SUBJECT: RESPONSE TO THE NOTICE OF DISAPPROVAL FOR THE PUEBLO CANYON AGGREGATE AREA INVESTIGATION WORK PLAN DATED JULY 26, 2005

**Response to the Notice of Disapproval for the
Pueblo Canyon Aggregate Area Investigation Work Plan
Dated July 26, 2005**

**Response to the Notice of Disapproval for the
Pueblo Canyon Aggregate Area Investigation Work Plan
Dated July 26, 2005
Los Alamos National Laboratory EPA ID No: NM0890010515
HWB-LANL-03-007**

Figure 4.1-1. SWMU 00-018(a) proposed sampling locations and depths

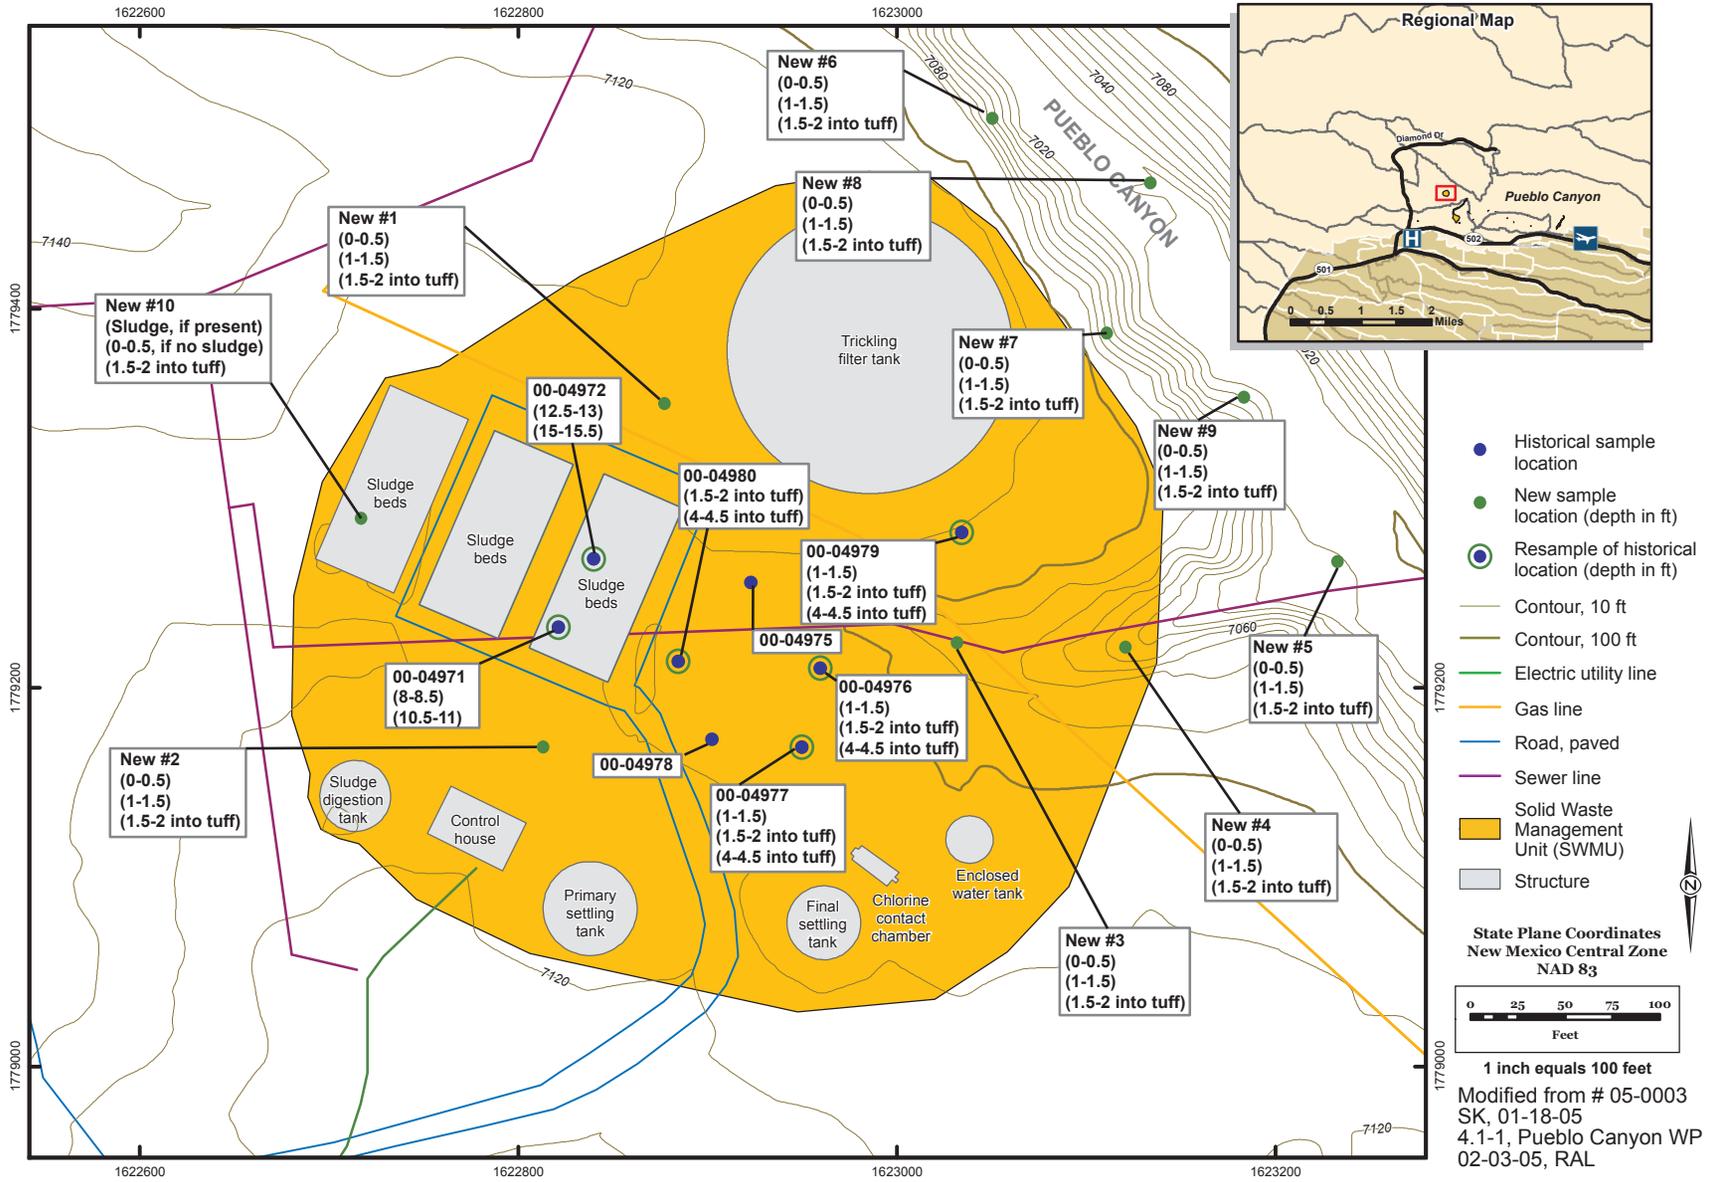
4. *Section 4.1 Sampling and Analysis for SWMU 00-018(a), Pueblo Canyon Wastewater Treatment Plant, pg. 80:*

The Permittees must collect two samples in the westernmost sludge bed to determine possible contamination that could have occurred if effluent exceeded permit limitations. The Permittees must collect one sample of the sludge and one sample of the underlying tuff. Also, see specific comment #2.

4. LANL will sample the westernmost sludge bed at SWMU 00-018(a) to determine possible contamination that could have occurred if effluent exceeded permit limitations. If sludge is present in the westernmost bed, two samples will be collected: one of the sludge material and one at a depth of 1.5–2 ft into the tuff. If no sludge is present, two samples will be collected, one in the surface soil/fill at 0–0.5 ft and one at a depth of 1.5–2 ft into the tuff, and analyzed for target analyte list (TAL) metals, volatile organic compounds (VOCs), semivolatile organic compounds (SVOCs), polychlorinated biphenyls (PCBs), pesticides, and radionuclides using gamma spectroscopy. Additionally, all samples will be analyzed for pH, nitrates, cyanide, and perchlorate.

The revised text (pp. 80–81), Table 4.1-1, and Figure 4.1-1 are provided in Attachment 2.

Figure 4.4-1. AOC 00-030(eN) proposed sampling locations and depths

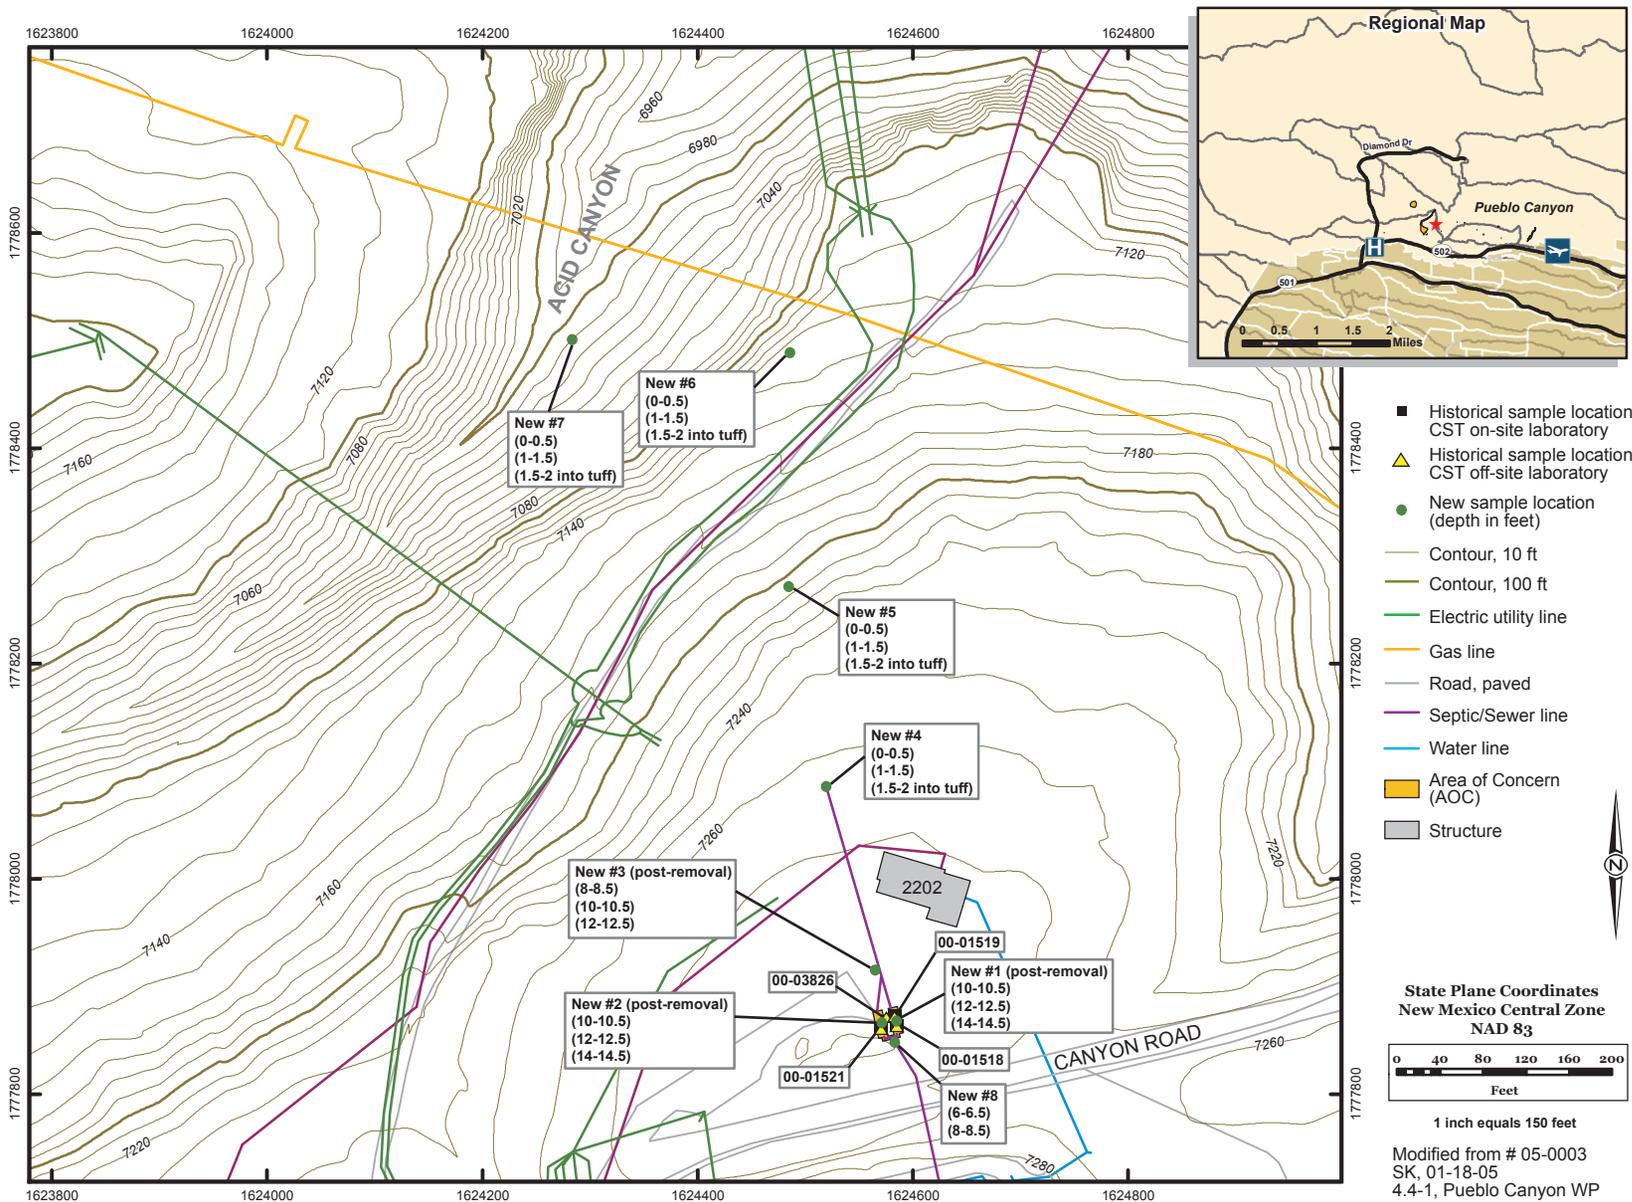
6. *Section 4.4 Sampling and Analysis for AOC 00-030(eN), Septic System, pg. 83 and Section 4.6 Sampling and Analysis for AOC 00-030(f), Septic System, pg. 85:*

The Permittees state that the removal of “the structures, however, is contingent upon the approval of respective property owners, the conditions of the access agreements, and an evaluation of any overlying structures that could be negatively impacted by excavation.” However, the Permittees did not provide an alternate to structure and soil removal if it is deemed impossible. The Permittees must describe a contingency plan for investigation of these sites.

The Permittees must also explain if the drainline removal at AOC 00-030(eN) includes the inlet pipe that, according to Figure 1.1-6, extends from the tanks to a location south of Canyon Road.

6. LANL is not proposing removing the inlet pipe at Area of Concern (AOC) 00-030(eN). LANL’s alternate plan for investigating at AOC 00-030(eN), if structure and soil removal is deemed impracticable, is to sample beneath the current tank locations using one or more angled borehole(s). The depth to the bottom of the tanks is estimated to be approximately 13 ft below ground surface (bgs), corresponding to a tank height of 8 ft beneath 5 ft of fill. The target total depths for samples collected beneath each tank with angled boreholes, if required, will be 15–15.5 ft and 17–17.5 ft bgs. If the tank cannot be removed, LANL proposes trenching upgradient of the tanks to locate the inlet piping and collect samples from the area of the inlet connection(s) to the tanks. Samples will be collected at 6–6.5 ft and 8–8.5 ft bgs at the inlet pipe location and analyzed for TAL metals, VOCs, SVOCs, PCBs, pesticides, americium-241, and radionuclides using gamma spectroscopy. Additionally, all samples will be analyzed for pH, nitrates, cyanide, and perchlorate.

The revised text (pp. 84–85), Table 4.4-1, and Figure 4.4-1 are provided in Attachment 2.

Figure 4.8-1. AOC 00-030(j) proposed sampling locations and depths

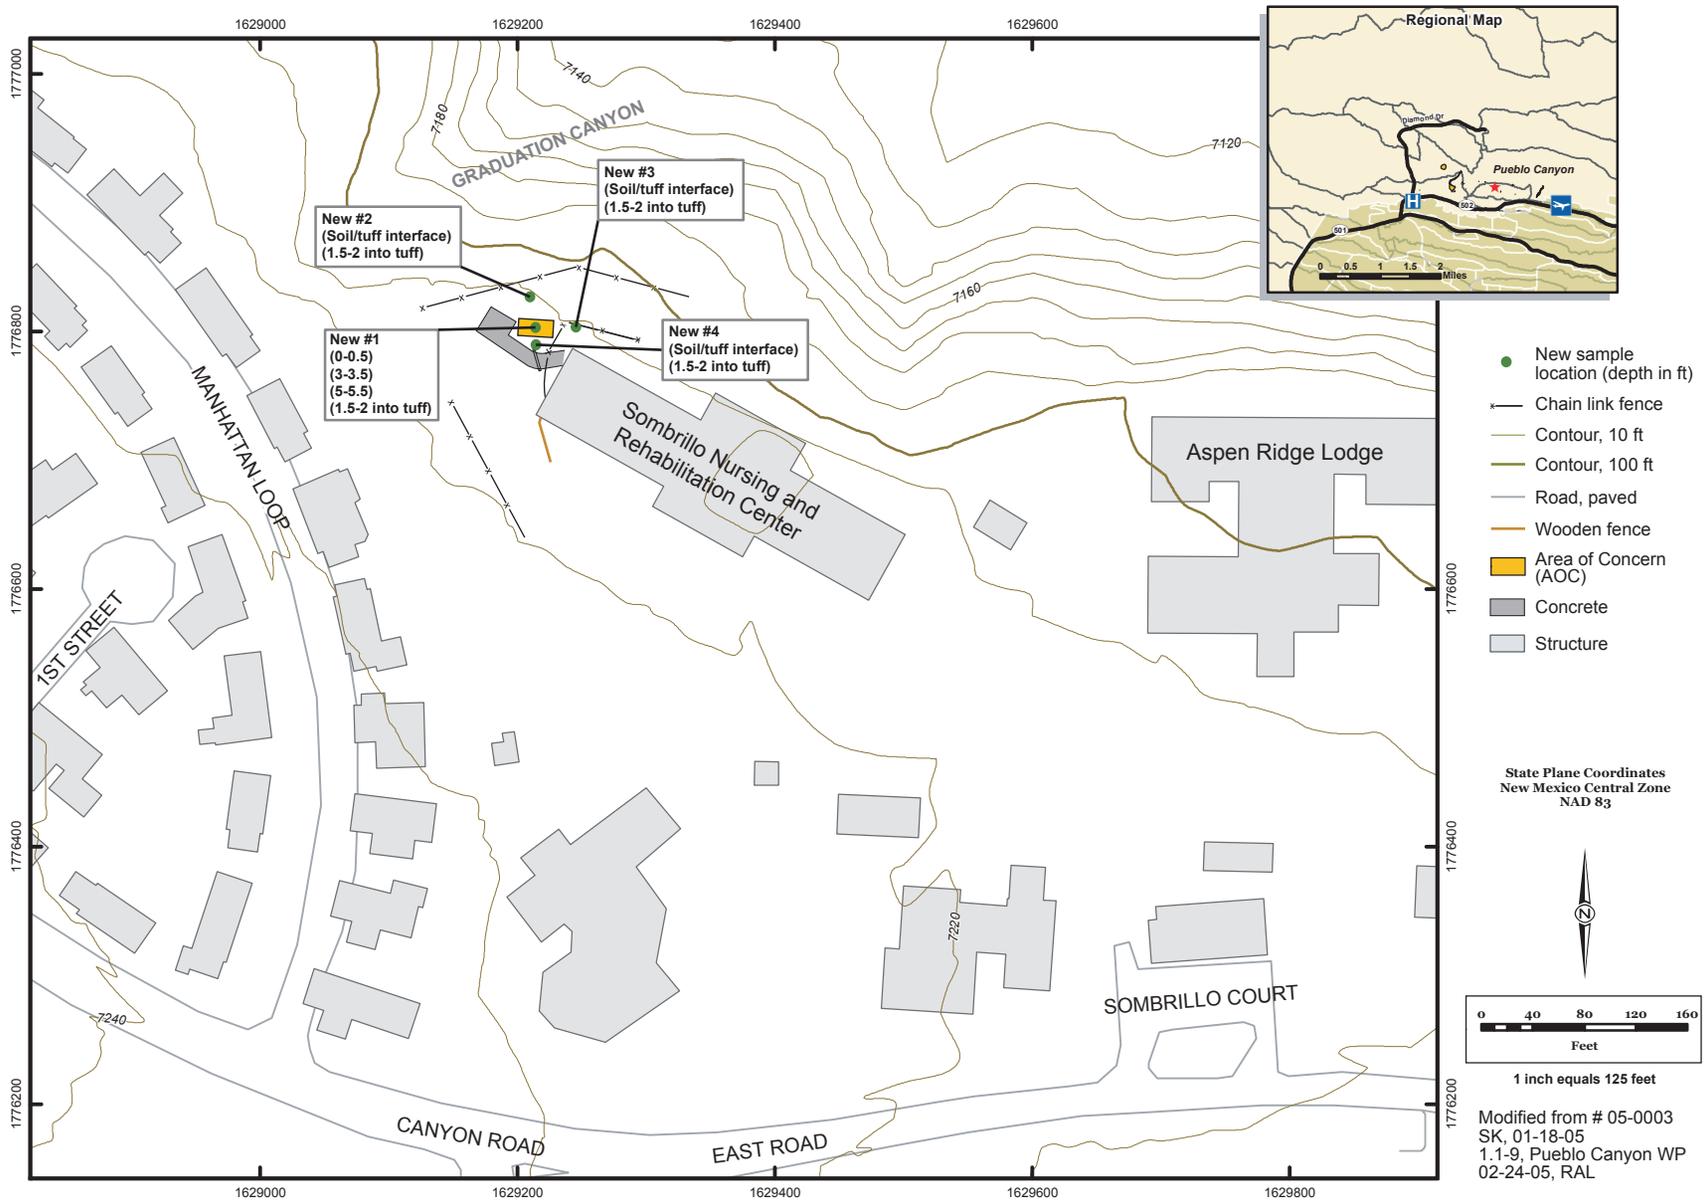
7. *Section 4.8 Sampling and Analysis for AOC 00-030(j), Septic System, pg. 87:*

NMED does not agree with drilling one borehole in a location that may not coincide with the former septic tank. In addition, if the tank has been removed, the sampling media will consist of fill material overlying tuff. Any samples collected of the fill material above the tank will not be representative of a release from the tank. Instead, NMED requires drilling 3-4 boreholes in the vicinity of the presumed tank location and collecting a sample from the fill /tuff interface depth in each borehole.

7. Based on a review of historical information and the results of a 1996 geophysical survey conducted at AOC 00-030(j), LANL has concluded that the septic tank was never installed. However, three additional boreholes will be advanced around the perimeter of the presumed tank location (based on 1947 engineering drawings). Samples will be collected at each of the perimeter locations from two depths, one at the soil/tuff interface and one at 1.5–2 ft into the tuff, and analyzed for TAL metals, VOCs, SVOCs, PCBs, pesticides, and radionuclides using gamma spectroscopy. Additionally, all samples will be analyzed for pH, nitrates, cyanide, and perchlorate.

The revised text (p. 89), Table 4.8-1, and Figure 4.8-1 are provided in Attachment 2.

Figure 4.9-1. AOC 00-030(n) proposed sampling locations and depths

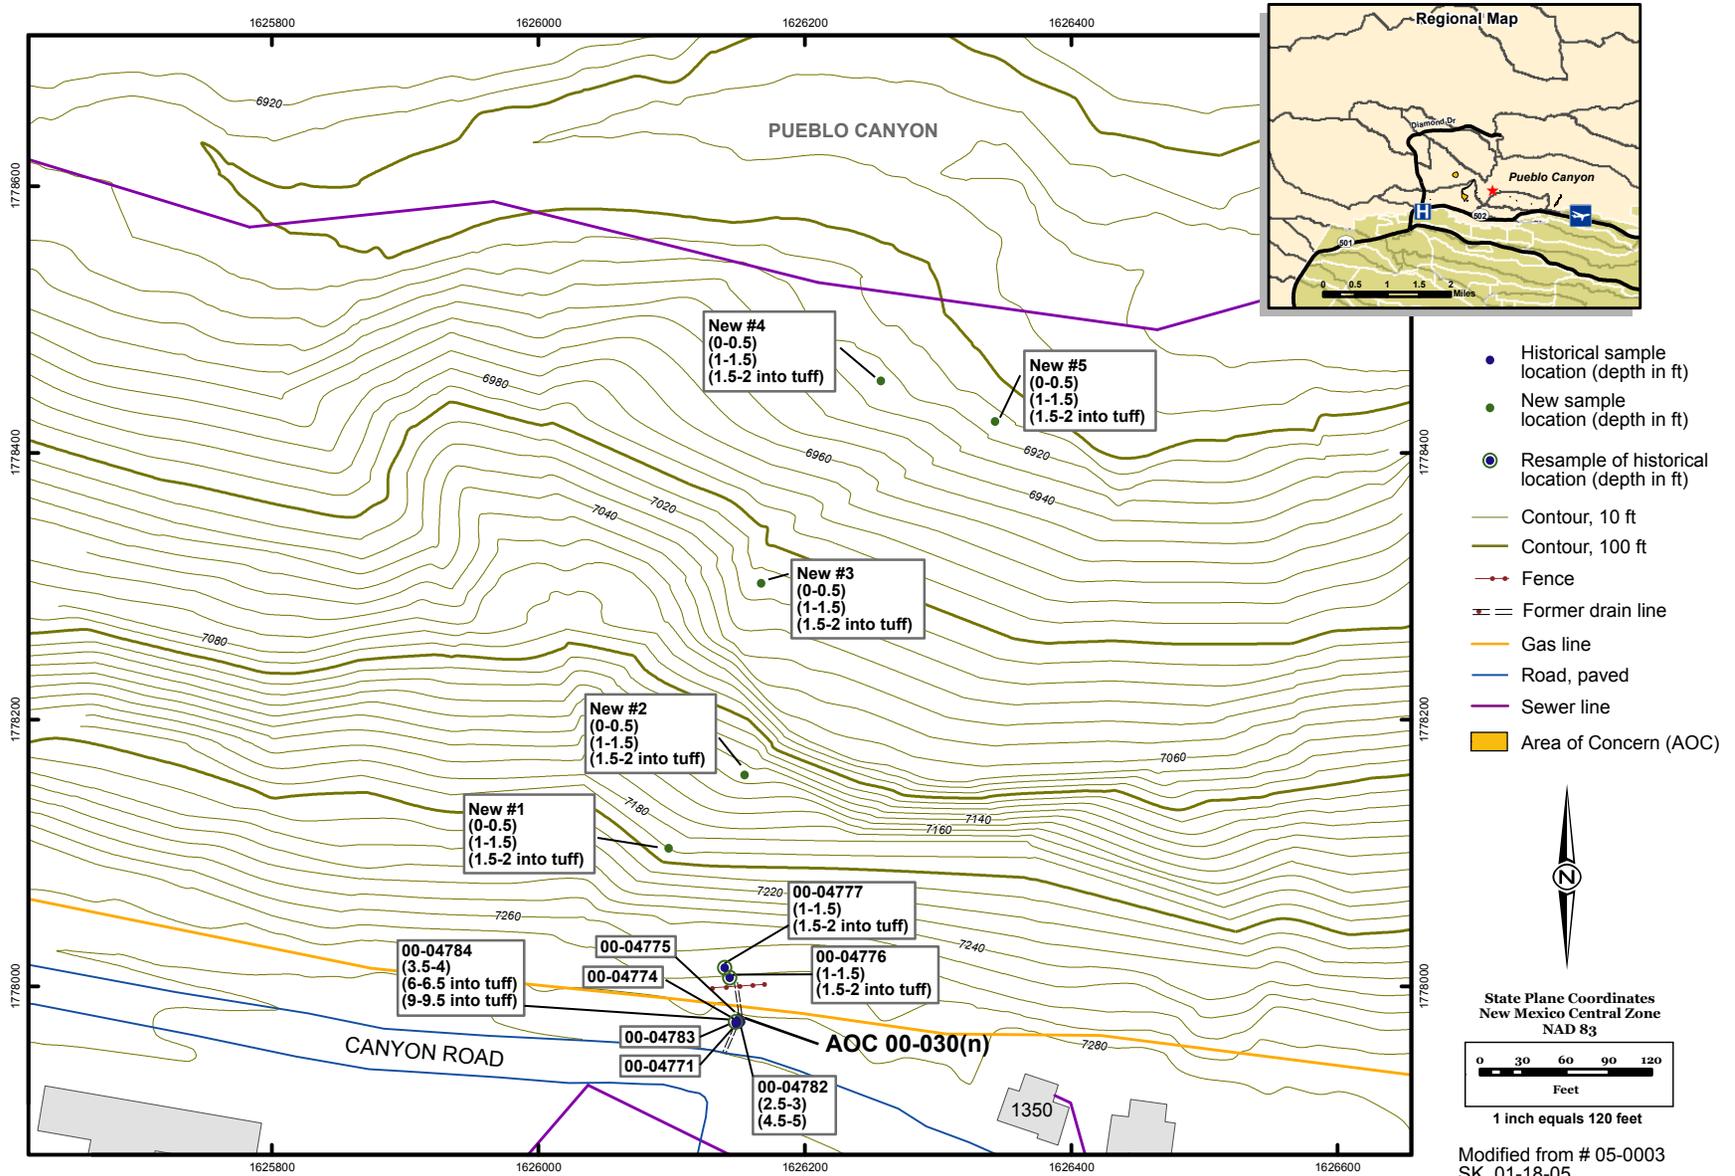
8. *Section 4.9 Sampling and Analysis for AOC 00-030(n), Septic System, pg.88:*

Sampling performed at a location underneath the inlet pipe detected some metals above background or had elevated detection limits. The Permittees must sample at this location (00-04782) in order to include the inlet pipe as part of the vertical contamination investigation.

- LANL proposes collecting additional samples at historical location 00-04782 to investigate potential vertical contamination of metals at the inlet pipe at AOC 00-030(n). Samples will be collected at two depths, 2.5–3 ft and 4.5–5 ft bgs, and analyzed for TAL metals.

The revised text (pp. 89–90), Table 4.9-1, and Figure 4.9-1 are provided in Attachment 2.
